EXHIBIT 2 - STAFF REPORT

DATE: July 25, 2019
TO: Historic Landmarks Committee Members
FROM: Chuck Darnell, Senior Planner
SUBJECT: DDR 1-19 – 1025 NE 1st Street – Review of Built Example of Exterior Materials

Photos of the new built example are provided below:

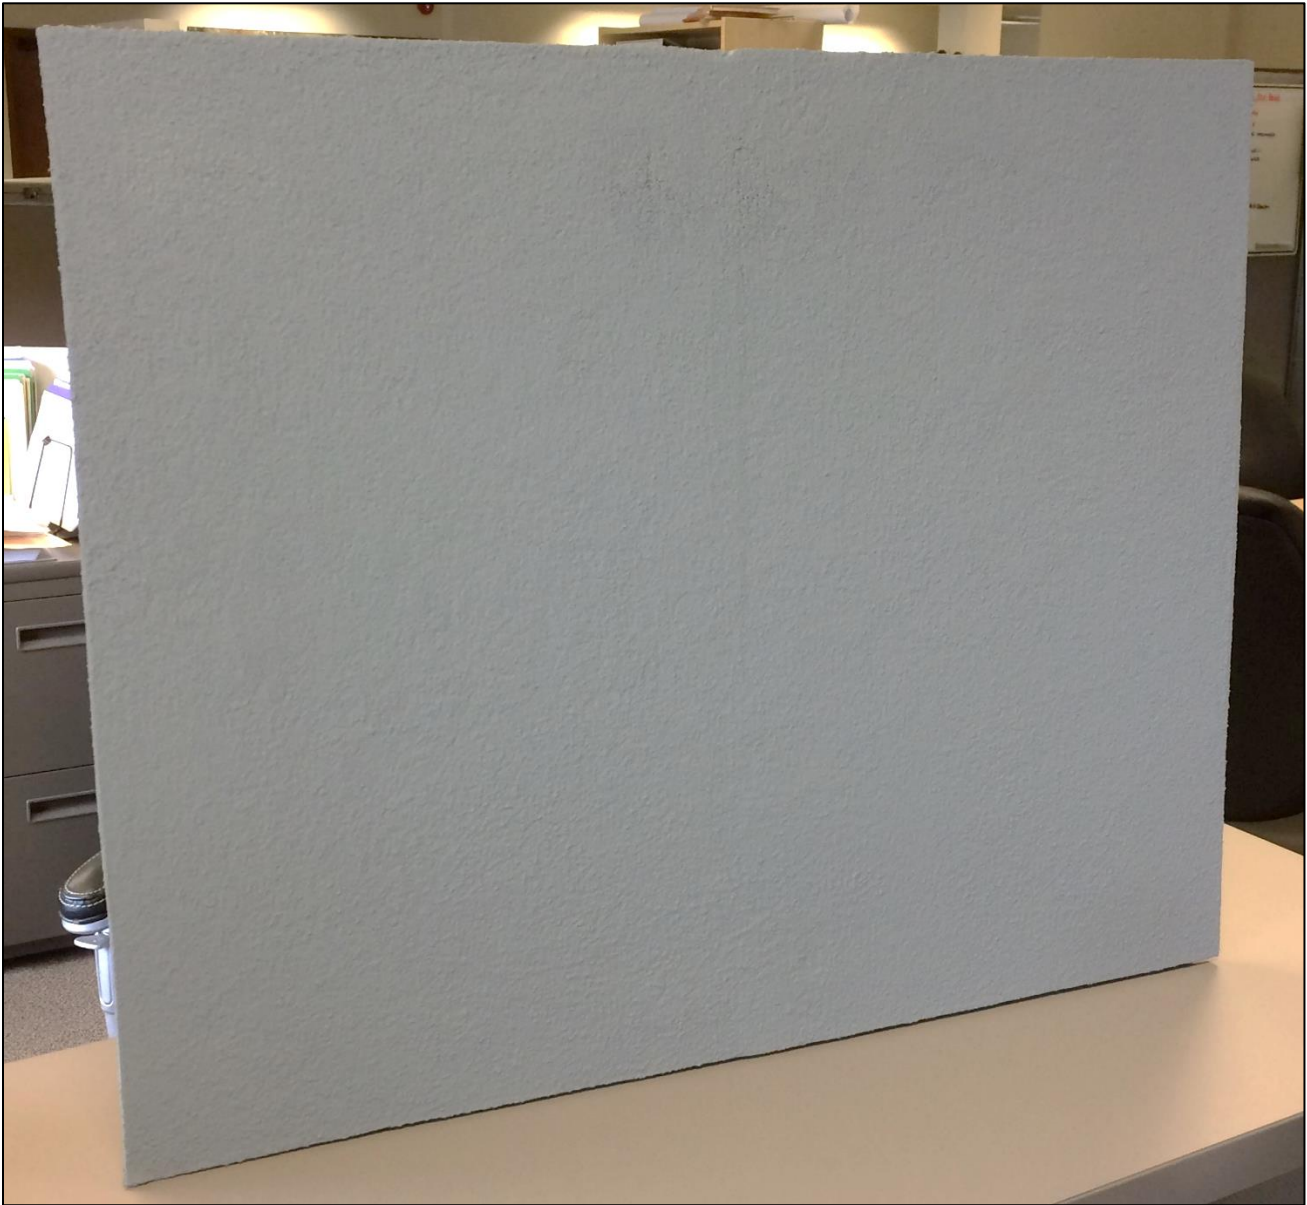
The applicant provided a built example of the proposed fiber cement panels that includes a portion of the proposed vertical reveal joint between the panels. This built example was reviewed by the Historic Landmarks Committee at meetings on May 30, 2019 and June 26, 2019. The Historic Landmarks Committee did not find that the built example met the applicable Downtown Design Standards in Section 17.59.050(C)(1) because the materials used were not found to be similar in appearance to “smooth stucco”, as stated in the original application submittal and applicant’s findings, and also that the material was not similar in appearance to other “building materials found on registered historic buildings in the downtown area”. The vertical seam and reveal joint was also found to still be very visible and prominent. Comments were provided back to the applicant by letter on June 6, 2019 and in person on June 26, 2019, and the applicant stated that they would prepare another built example that better responded to the Historic Landmarks Committee’s findings and the applicable Downtown Design Standards. The new built example uses the same fiber cement panels, but includes a caulking of the seam between panels and the application of a finish of paint with a sand additive that creates a textured appearance that is similar to the “smooth stucco” exterior building material that is allowed by Section 17.59.050(C)(1).

The applicant has provided the new built example, and it will be available for review by the Historic Landmarks Committee at the July 25, 2019 meeting. The built example is also available at the Planning Department office at the Community Development Center (231 NE 5th Street), if any Committee member would like to stop in to review the built example prior to the meeting.

Staff finds that the new built example, which still includes the use of the fiber cement panels, is similar in appearance to smooth stucco and that the applicant has provided an example treatment that minimizes the visibility of the seam between the panels. The treatment used was a finish of paint with a sand

additive, which creates a texture on the exterior building material more consistent with the appearance of smooth stucco. This treatment is proposed to be used on the entire building façade.

Based on this new built example, staff recommends that the Historic Landmarks Committee approve the use of the material, with the treatment depicted in the built example.

Village Quarter 4th Street (north) building façade:

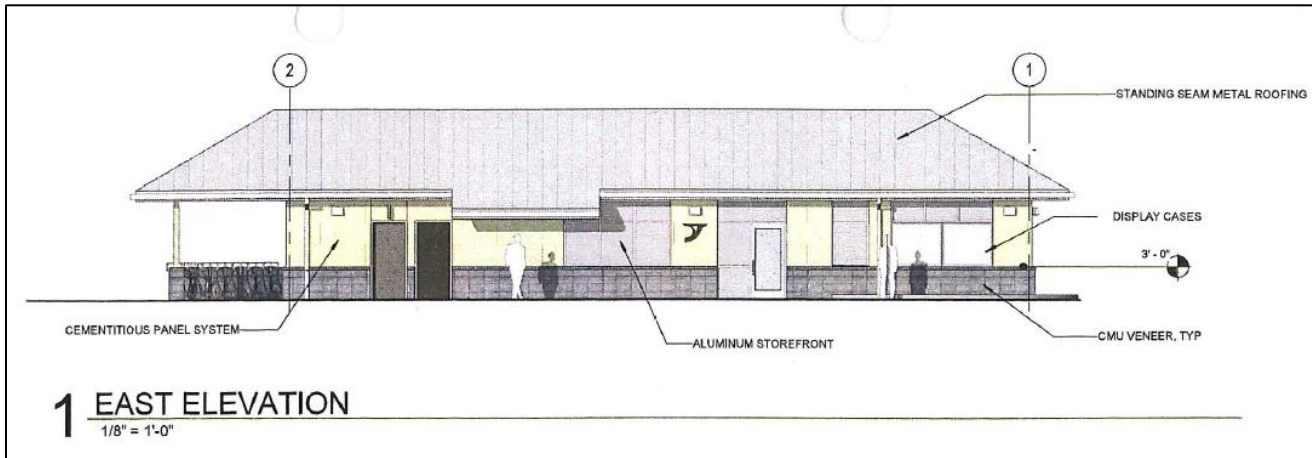
Staff would note that there are some differences in the application of the cement panels on the Village Quarter building as compared to what is proposed on the new apartment building at 1025 NE 1st Street. The cement panel material is not the primary exterior building material on the Village Quarter's main street-facing façade (3rd Street). The concrete panels on the 3rd Street façade of the Village Quarter building are visible on a portion of the façade, with brick and storefront glazing being the more primary building materials. The use of the cement panel material is more prominent on the side and rear facing facades, such as the west façade adjacent to the railroad tracks and the north side adjacent from 4th Street. However, there is still brick in portions of each of those façades.

The Village Quarter building's use of cement panels differs from the current proposal at 1025 NE 1st Street, which includes the use of only concrete panel material on three street facing facades. There is also more articulation in the Village Quarter building's façades overall through the transitions in building materials, openings in walls, changes in building planes, and an overhanging eave along the top of the building. The visible concrete panel seams and fasteners are more integrated with the building's architectural features, as they line up with the edges of windows and the corners that transition into the upper level balconies. While not documented as part of the former Planning Director's review of the project against the Downtown Design Standards, these other building design features may have been considered when evaluating the use of the cement panel material on portions of the building façade.
